Intel[®] 81341 and 81342 I/O Processors

Specification Update

September 2008

Order Number: 315042-007US

Figure 8. VCC1P2PLLS0, VCC1P2PLLS1 Low-Pass Filter

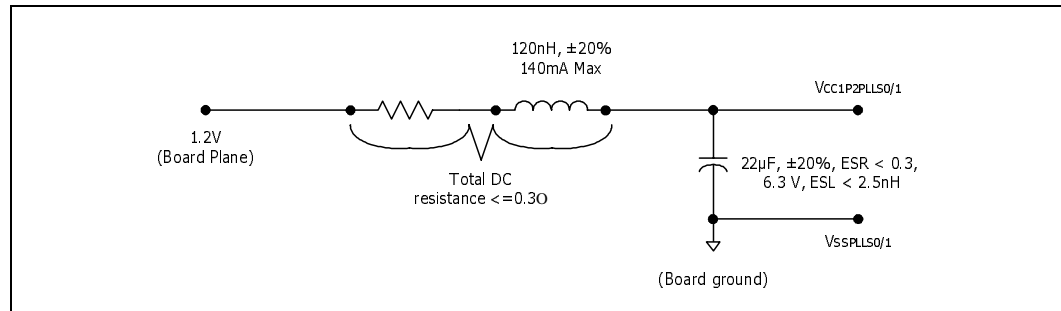
Problem: The VCCPLL Pin Requirements section of the Datasheet have changed. See below for the updates in Section 4.1 and Figure 8 in the Datasheet.

This paragraph pertains to the VCC1P2PLLS0, VCC1P2PLLS1 filters. The recommended filter for the PLL supplies is shown in Figure 8. The purpose of this filter is to achieve at least 10 dB rejection of frequencies between 1 and 20 MHz. The board supply distribution system must ensure that the minimum voltage into the PLL ball is equal to or greater than 1.164 V. The current draw for the IC is 95 mA typical less than 140 mA maximum. The filter components are selected to achieve a corner frequency of 100 KHz. The series resistance keeps the Q of this resonant circuit safely below unity for all component variations. The total DC resistance of the resistor and the inductor must be equal to or less than 0.3 Ohms.

The bypass capacitor must be placed as close to the supply pins as possible. The series impedances to both the supply pin and the PCB analog ground plane must be an order of magnitude lower than the ESR and ESL specified for the capacitor. The S0/S1 PLLs have dedicated internal supplies, so the VSSPLLS0/S1 pins must be soldered directly to the analog ground plane of the PCB.

New Figure 8:
